ADDENDUM NO. 1

April 18, 2017

TO THE CONTRACT DOCUMENTS FOR
PIEDMONT HILLS HIGH SCHOOL
Building D Science & Classroom Buildings
for the
EAST SIDE UNION HIGH SCHOOL DISTRICT

DSA # 01-116180 - FILE NO. 43-H10

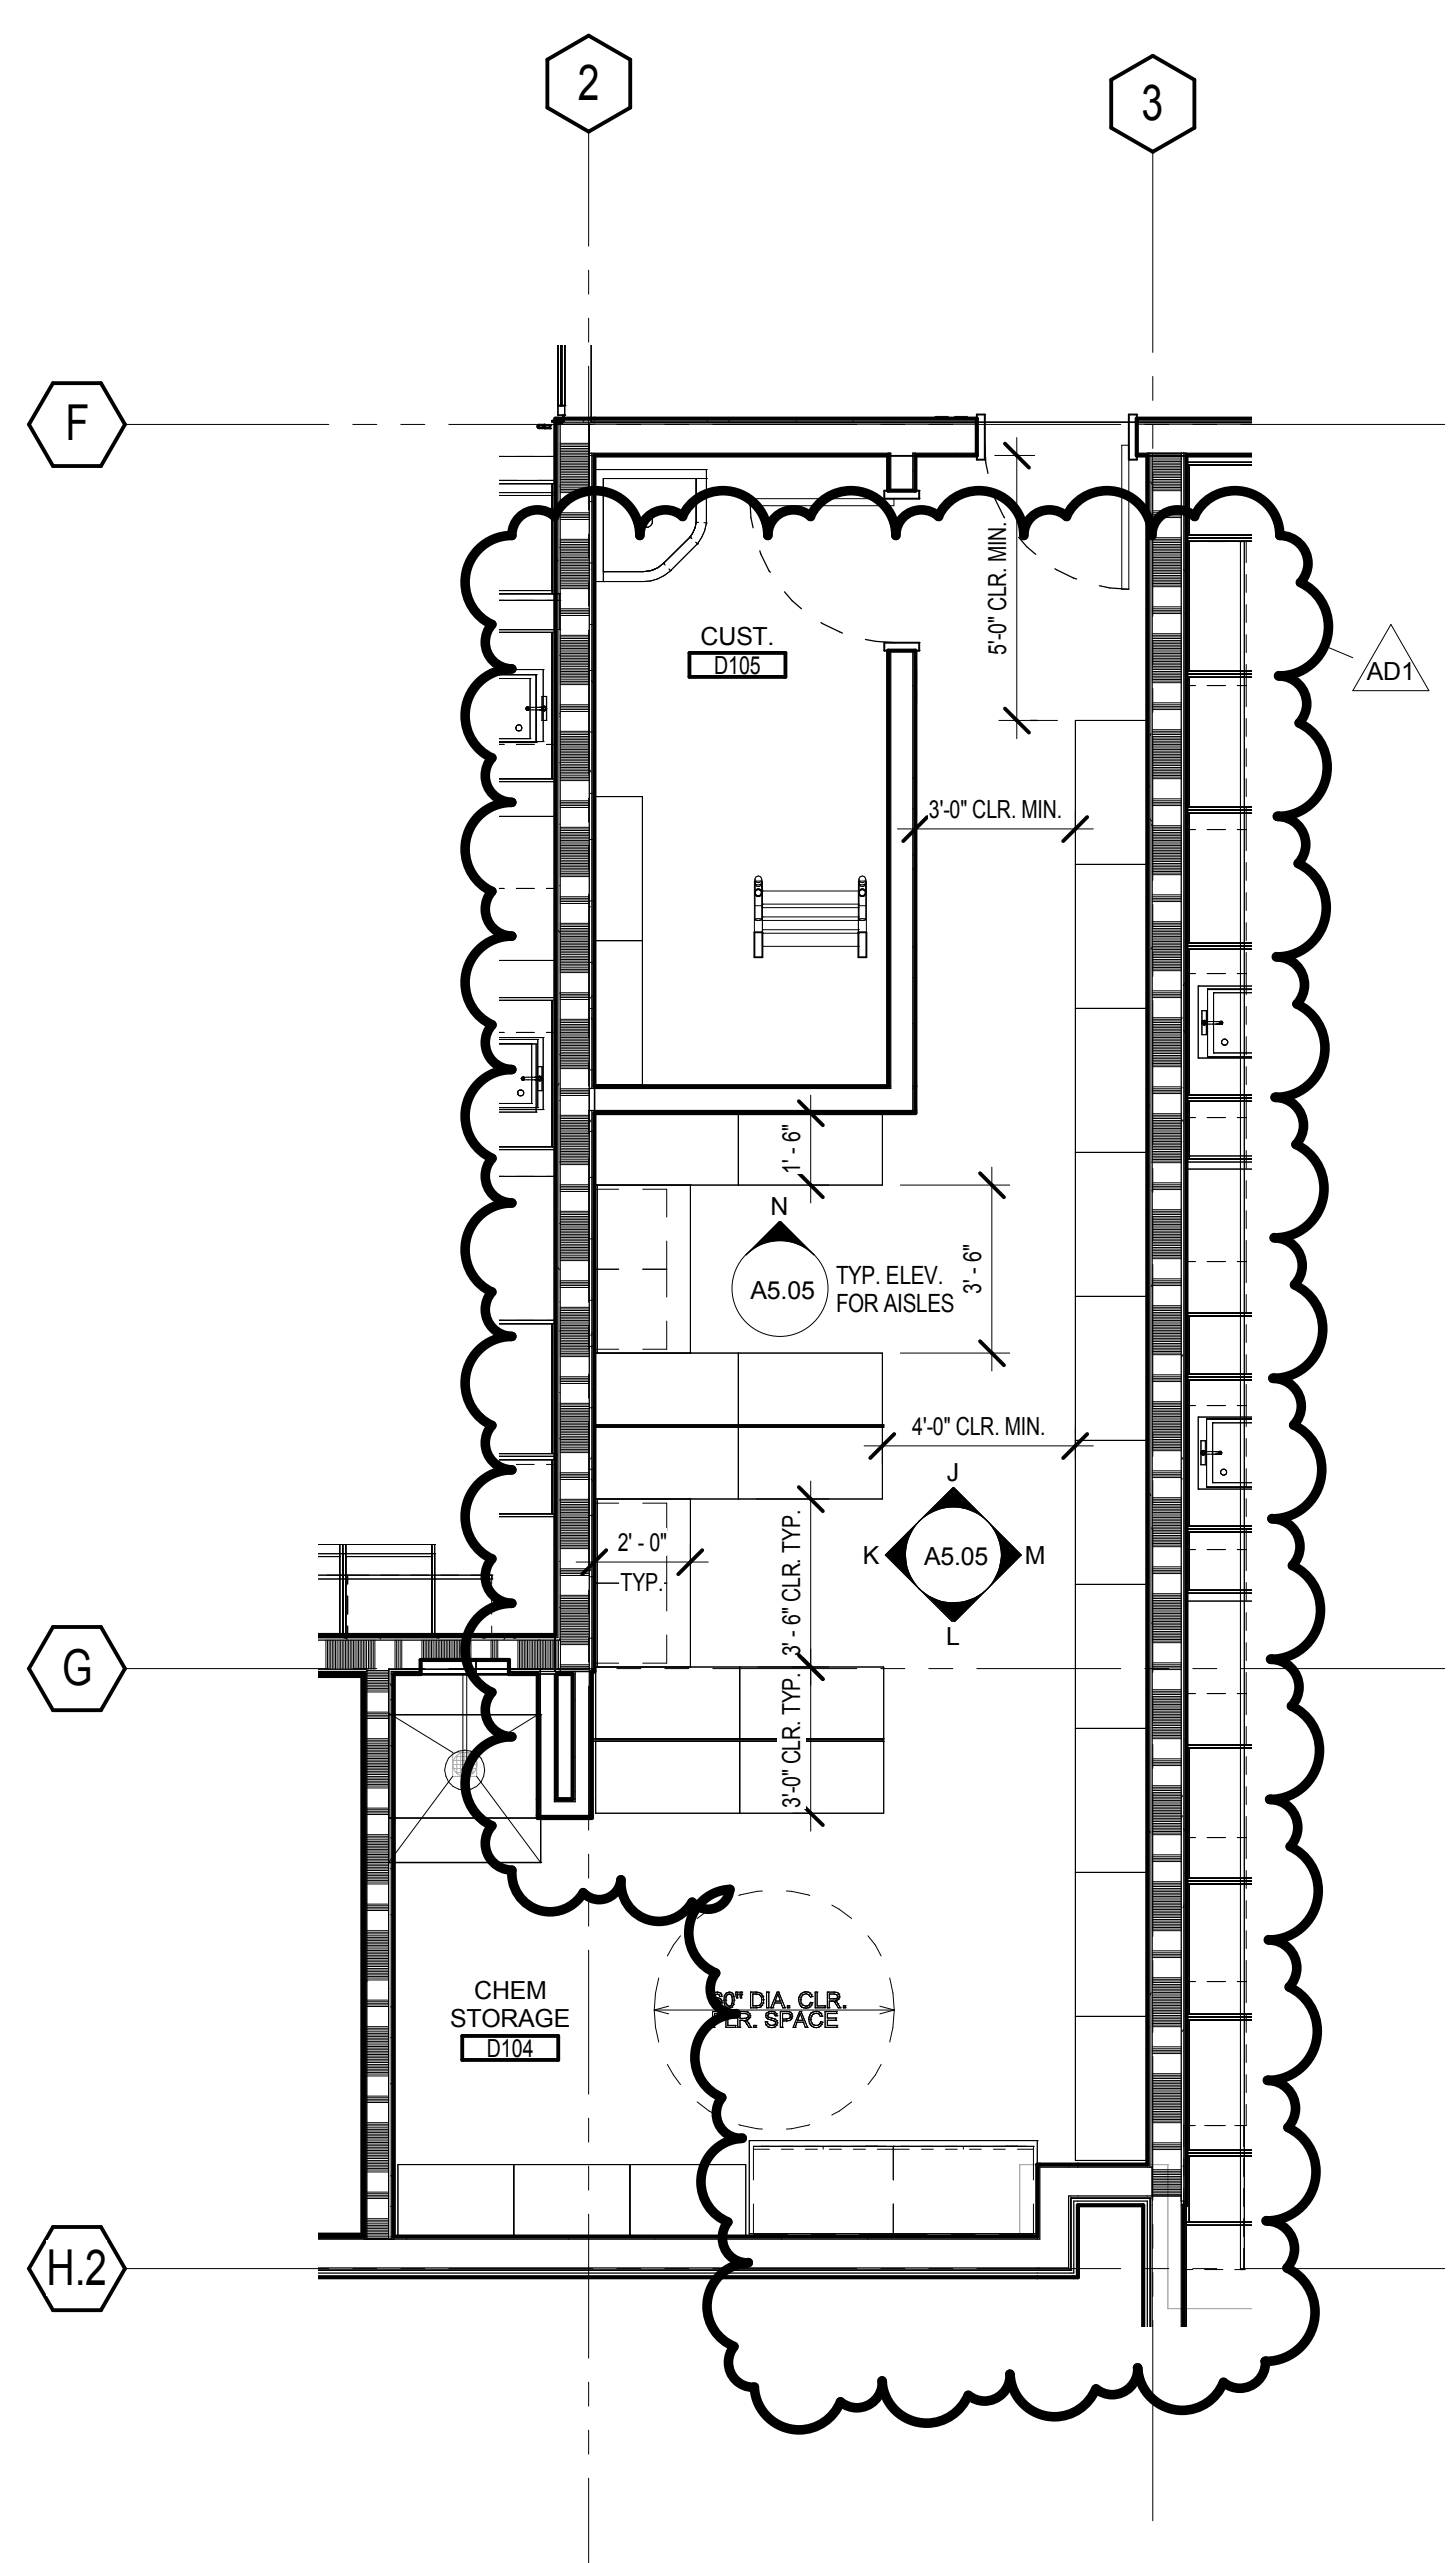
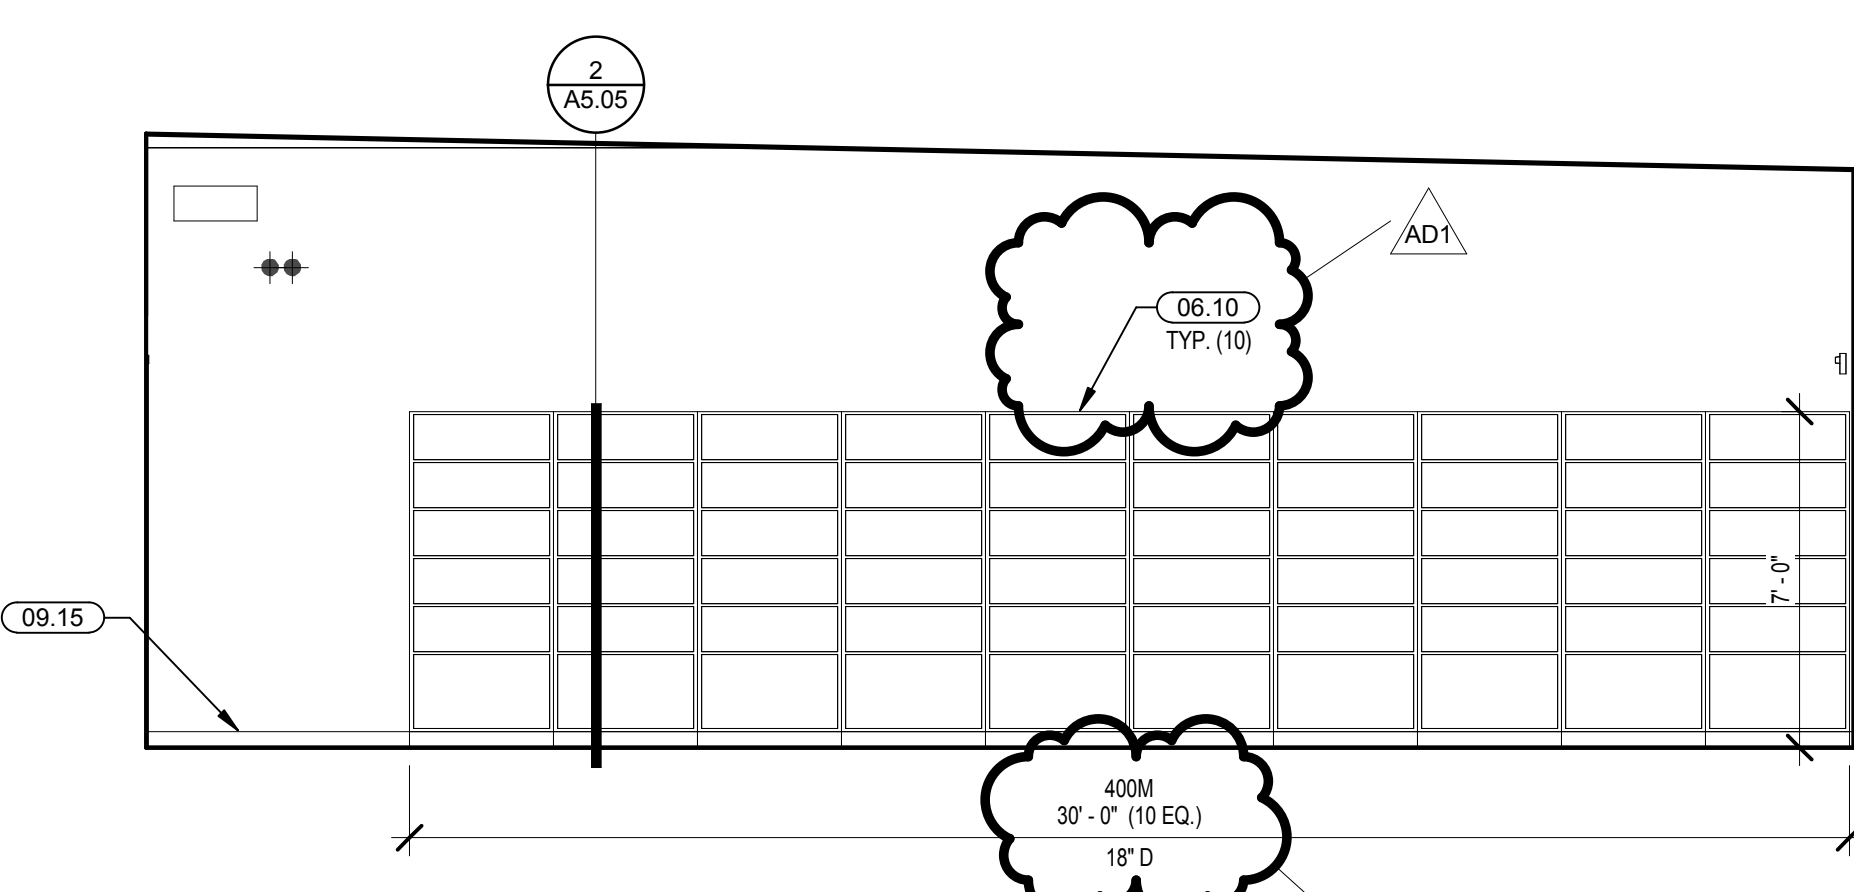
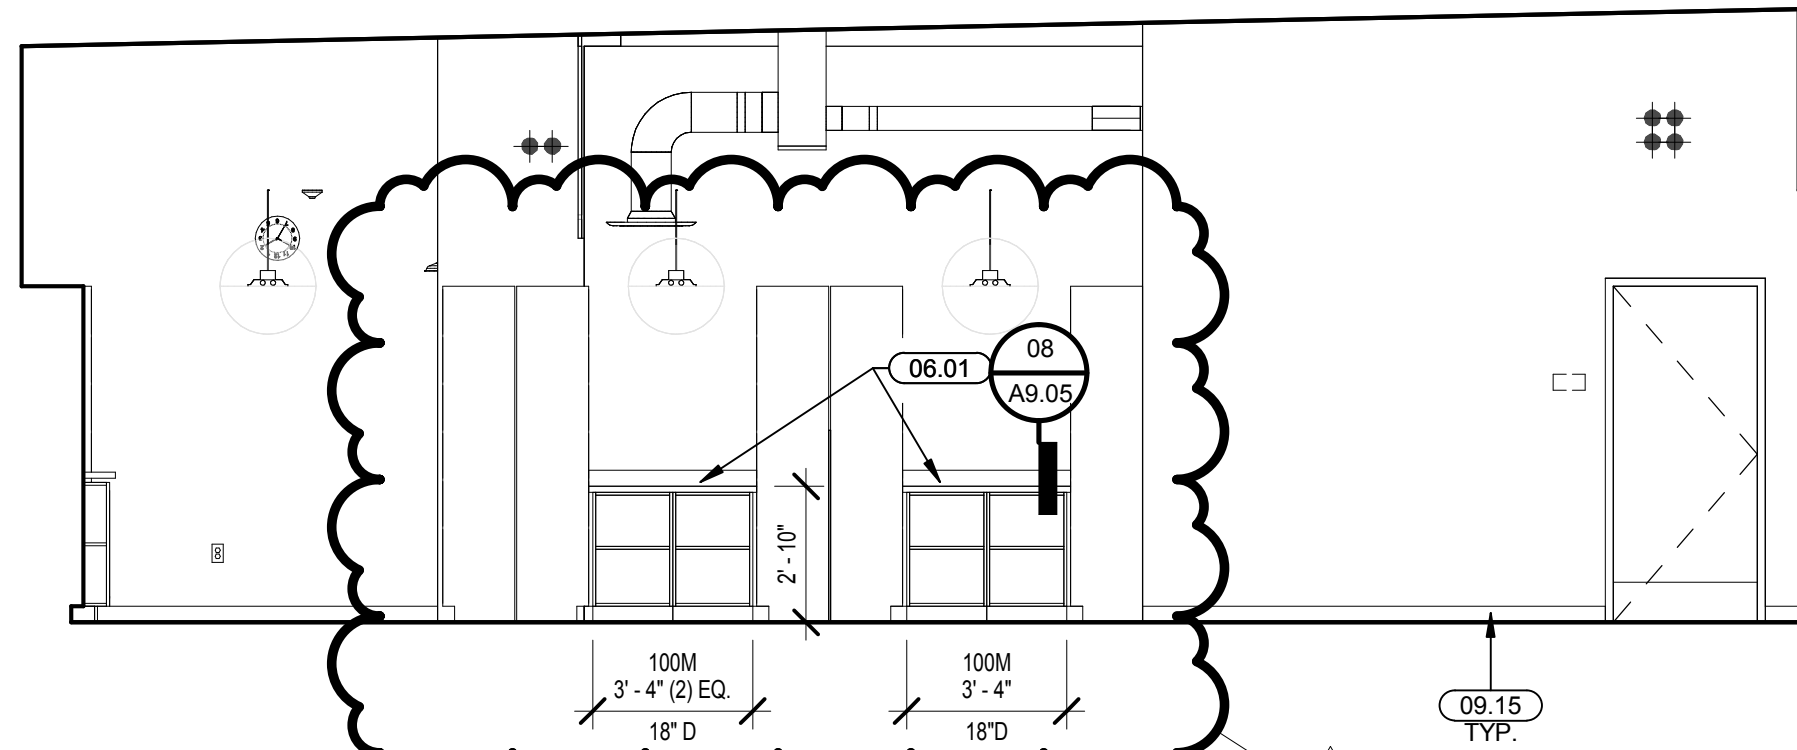
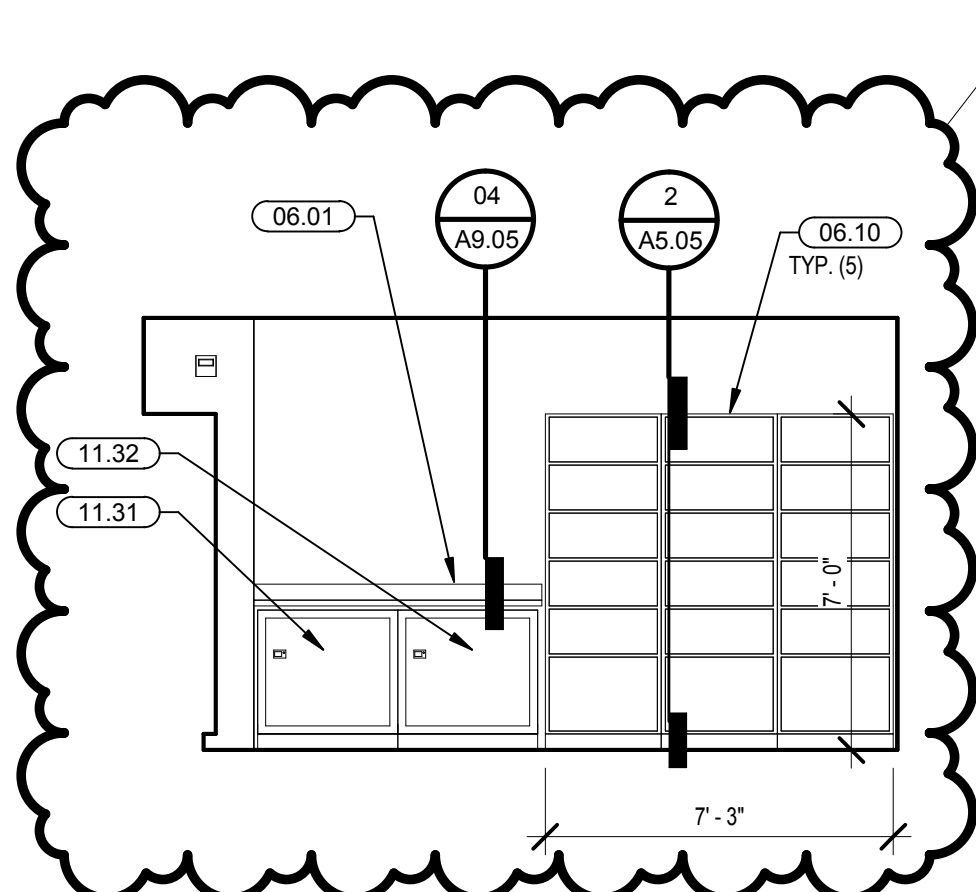
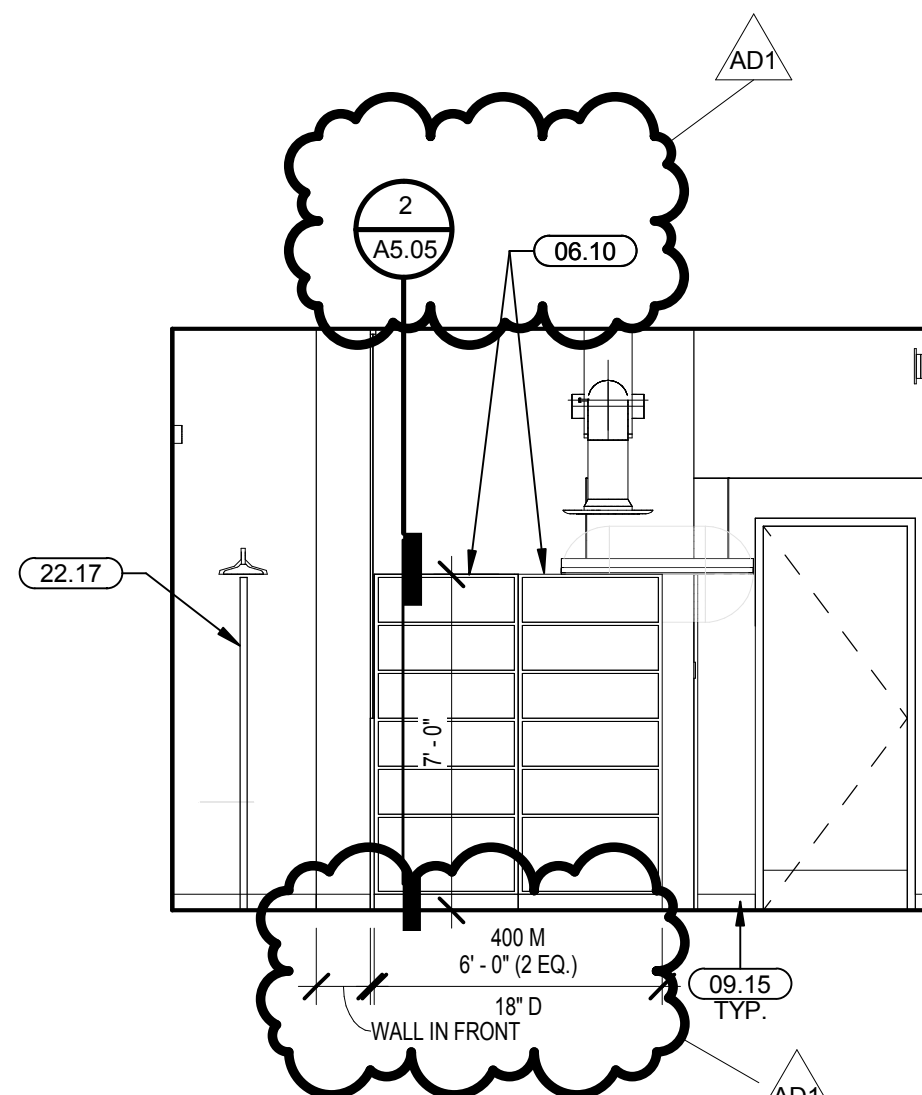
ITEM NO. AD1 -11 Remove sheet A5.05, Interior Elevations. Replace with sheet A5.05, Interior Elevations.

- a) Revise 01/5.05 Enlarged Plan – D104 Chem Storage casework.
- b) Revise interior elevations J, K, L and M to depict casework revisions.
- c) Provide casework per additional elevation N.
